Access Compliance Report

Public Rights-of-Way

(Pedestrian Signals)

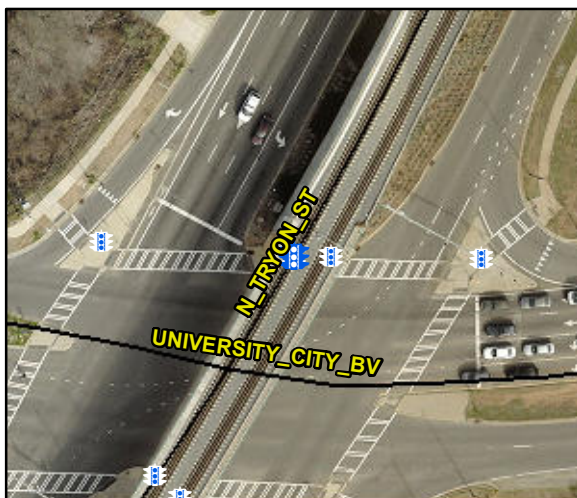
Surveyor Notes: TEXT HT 5/16

PROW/ADA: R410.6, TMUTCD 4e.08, R406.2, R404.7.3, R209.1, MUTCD 4e.10

Possible Solutions: Replace Signal Push Button With APS Button on New Post. Remove & Replace Sign.
